AMENDMENT OF SOLICITATION/MODIFICATION OF CONTRACT				1. CONTRACT ID CODE J		PAGE OF PAGES 1 7	
2. AMENDMENT/MODIFICATION NO. 0003		3. EFFECTIVE DATE 28-Jun-2004		4. REQUISITION/PURCHASE REQ. NO. W16ROE-4100-7736		5. PROJECT NO.(If applicable)

14. DESCRIPTION OF AMENDMENT/MODIFICATION (Organized by UCF section headings, including solicitation/contract subject matter where feasible.) The purpose of Amendment 0003 is to do the following changes to W912DS-04-R-0006, Explosive Research and Development Loading Facility: Delete attachment A in its entirety and replace with new attachment A- Room -by-room Requirements. Delete Attachment D in its entirety and replace with new attachment D - Environmental Assessment. Add Geotechnical Investigation Final Report to Attachment L. Add to Section 00120 Appendix B- Project Fact Sheet, Appendix C- Contracts in progress, and Appendix D- Past Performance Questionnaire. The closing date for Offer remains unchanged, 23 July 2004 at 2:00:00 PM EST. See Continuation Page of the SF 30.							
Except as provided herein, all terms and conditions of the document referenced in Item 9A or 10A, as heretofore changed, remains unchanged and in full force and ef

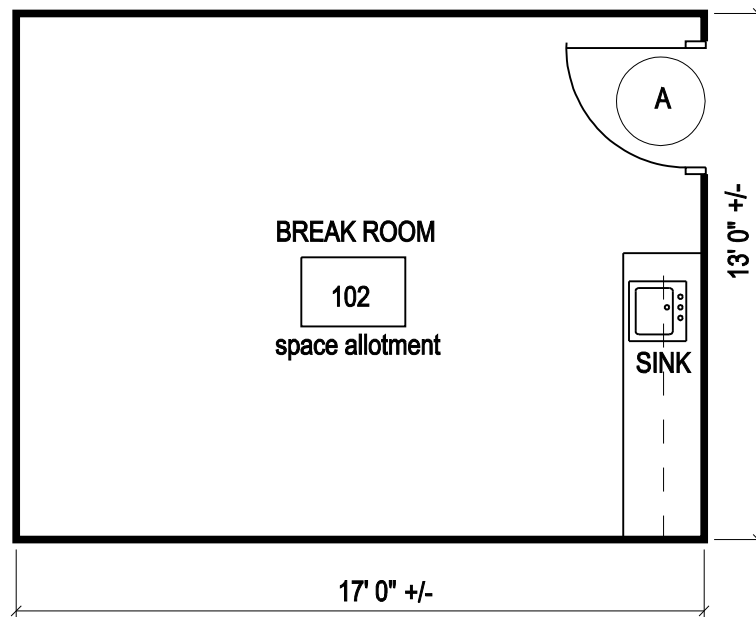
"E" type door to swing 180 degree to outside modified as per email: 5/25/2004 Addition to RFP
